Massachusetts Department of Transportation

Longfellow Bridge Rehabilitation Task Force Final Recommendations

Submitted October 29, 2010

Longfellow Bridge Rehabilitation Task Force

Three lane release into Charles Circle moving the abutment wall:

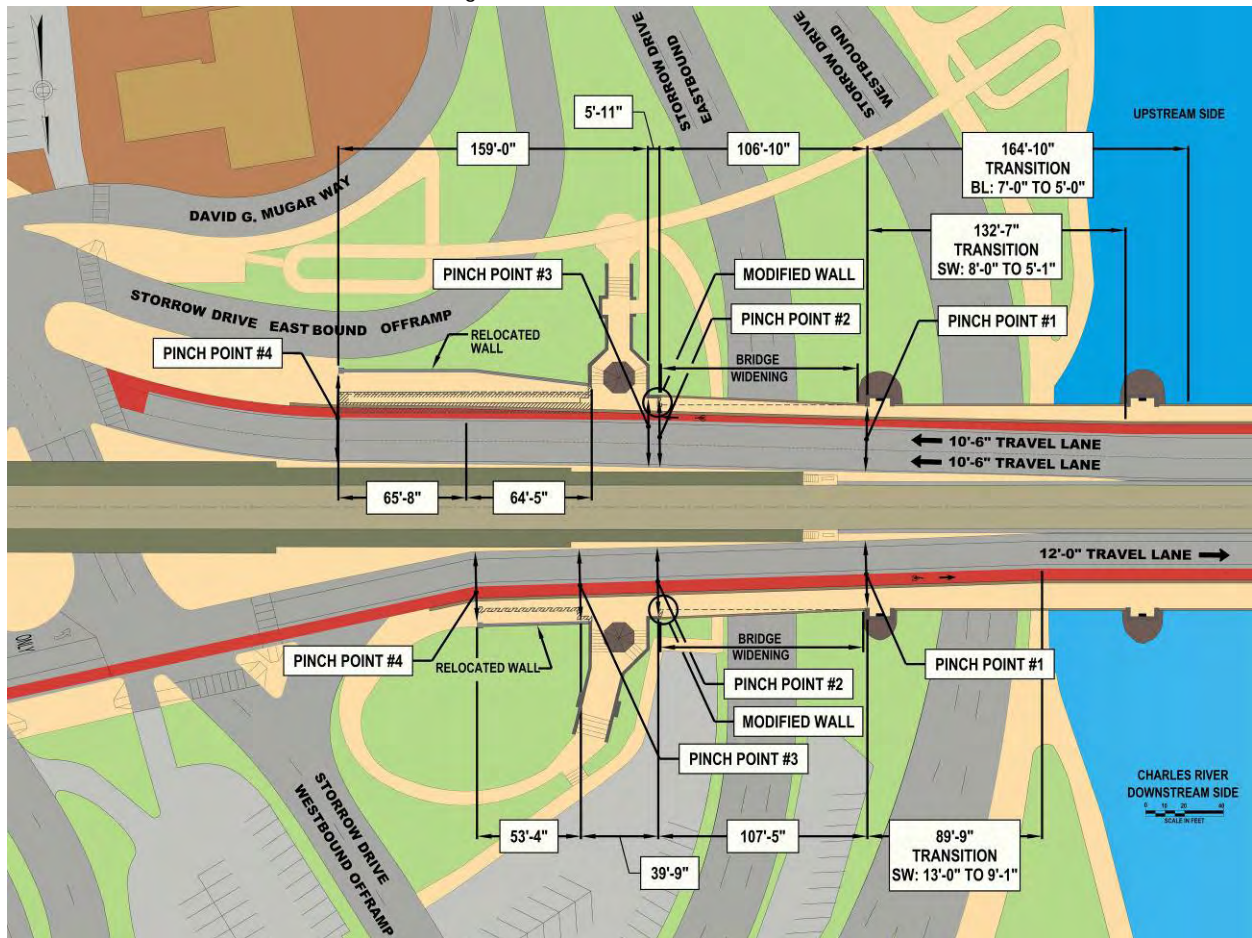
In this configuration the Task Force feels that the EA should evaluate whether the cycle lane should carry forward as shown in the drawing to allow direct travel through Charles Circle or placed to the right of all traffic in a similar fashion to that shown in the previous two graphics. If the bike/buffer lane narrows to 5 feet in total at the transition point/pinch points on the inbound side this would allow for the narrowest sidewalk at a pinch point to be wider than 5 feet.
